Re: Beacon Solar Energy Project, AFC No. 08-AFC-2

**APPLICATION FOR CERTIFICATION FOR  
THE BEACON SOLAR ENERGY PROJECT**

Supplemental Response to CEC Data Request 14 and  
Responses to CEC Data Requests 71 through 127  
Docket No. 08-AFC-2

<b>BEACON SOLAR ENERGY PROJECT (08-AFC-02)</b> <b>CEC STAFF DATA REQUEST NUMBERS 71-78</b>	
<b>Technical Area: Biological Resources</b>	<b>Response Date: October 13, 2008</b>

**Figure BR78-1**  
**Burrowing Owl Map**

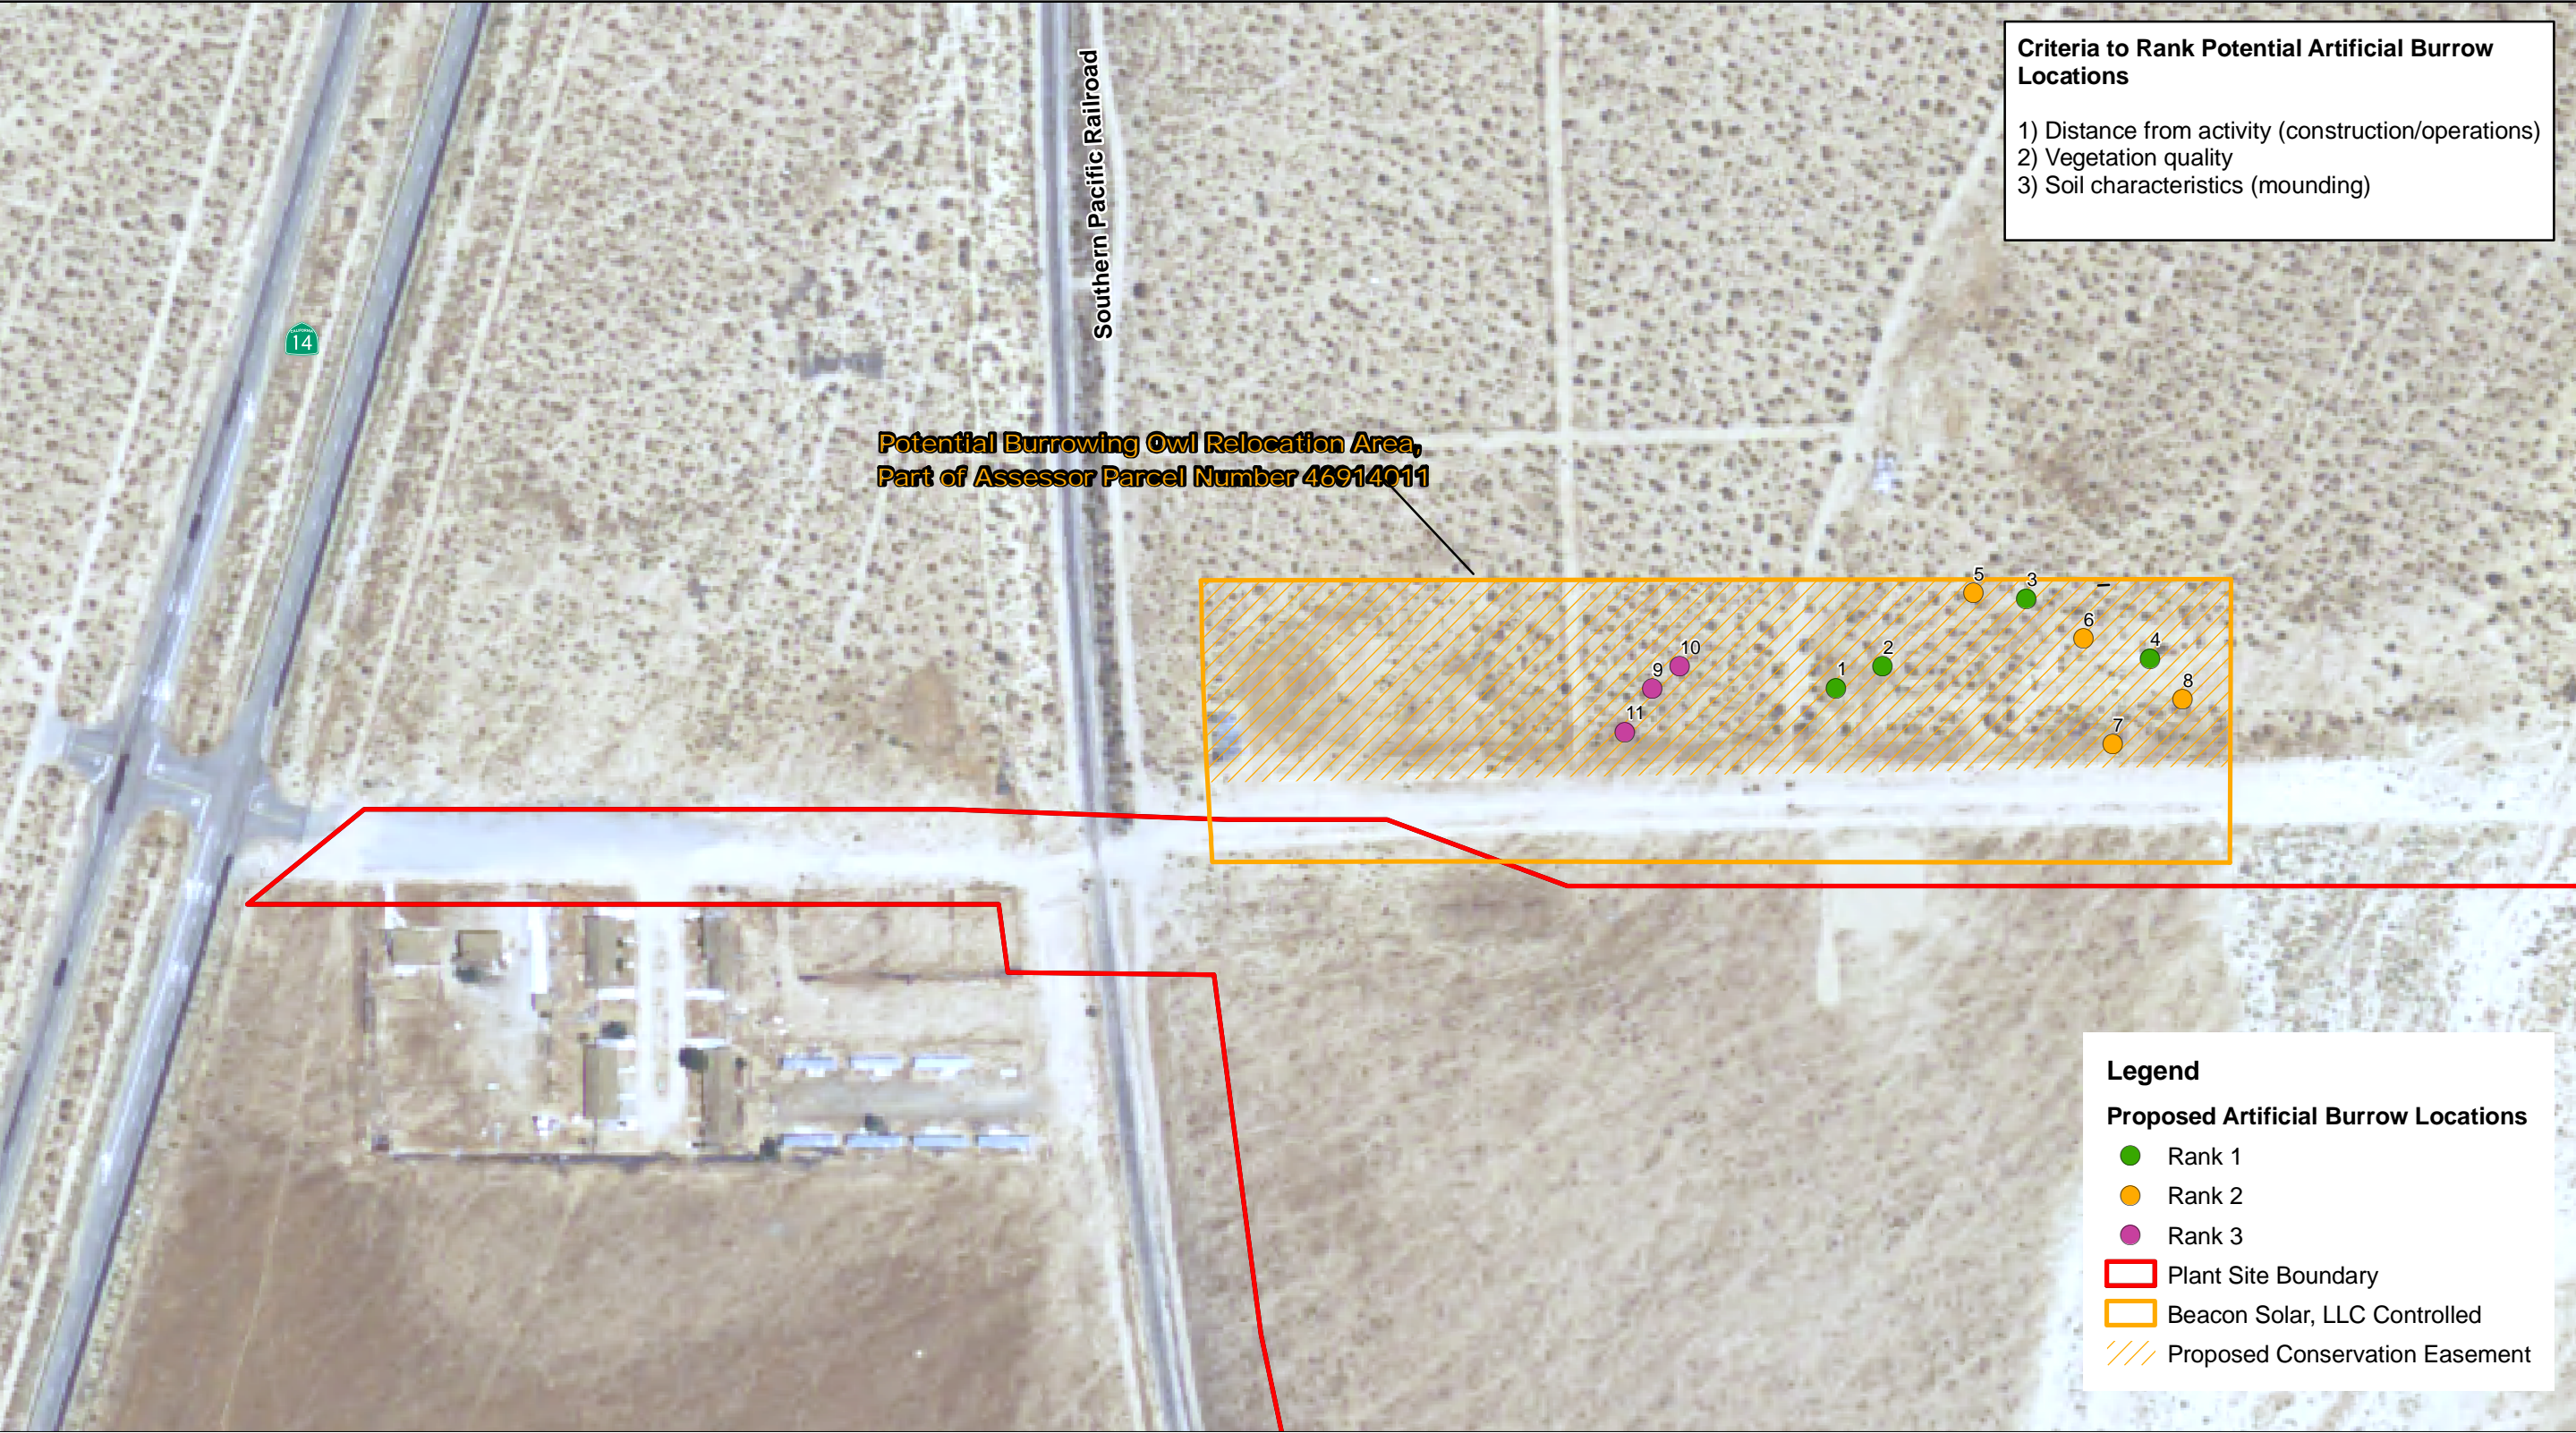
Please provide additional detailed, site-specific information as to how and where owls would be relocated off-site and how lands would be managed in the vicinity of the site for long-term preservation of this species. This relocation/preservation plan should reflect close coordination with the California Department of Fish and Game and the U.S. Fish and Wildlife Service and should include the following elements:

- a. A figure depicting the location of the off-site relocation area at a scale no less than 1 inch = 1000 feet;
- b. A description of the ownership of the relocation area, an assessment of habitat suitability of the area for burrowing owls, and a discussion of proposed management of habitat within the relocation site;
- c. A description of how lands would be managed near the Plant to promote long-term maintenance of a viable burrowing owl population; and
- d. A figure, at a scale of no less than 1 inch = 1000 feet, depicting the areas that would be subject to burrowing owl management.

The Project proposes the passive relocation of onsite burrowing owls to artificial burrows located off site. The artificial burrows will be located within a 14.39-acre parcel under the control of Beacon Solar, LLC. (Beacon) (Assessors Parcel Number [APN] 469-14-011), located just outside of the Plant Site boundary, east of State Route 14 (SR-14) and north of the facility access road (Figure BR78-1). The proposed relocation area is characterized by Mojave creosote scrub (*Chrysothamnus nauseosus*, dominant). Two potential burrowing owl burrows were identified in

the area during the spring 2007 and 2008 biological resource surveys, although neither was active and there was no burrowing owl sign associated with the burrows. One burrowing owl was observed immediately south of this area, inside the Project boundary. Figure BR78-1 shows a portion of the 14.39-acre parcel controlled by Beacon, proposed for artificial burrows construction in support of passive relocation. A thorough discussion of the proposed passive relocation effort was included with the Supplemental Response to CEC Staff Data Request No. 20 submitted on August 18, 2008.

To support protection and conservation of the burrowing owl within the relocation area, Beacon has agreed to establish a conservation easement over approximately six (6) acres of the parcel located north of the access road and east of SR-14 to protect the lands in perpetuity (Figure BR78-1). A total of four (4) artificial burrows will be constructed in this area to facilitate passive relocation of two pairs of burrowing owls identified previously on the Plant Site. The artificial burrows will be constructed as close to the northern border of the parcel as feasible to maximize distance between construction areas and the access road in an effort to decrease indirect disturbance and increase the potential for occupancy by burrowing owls.
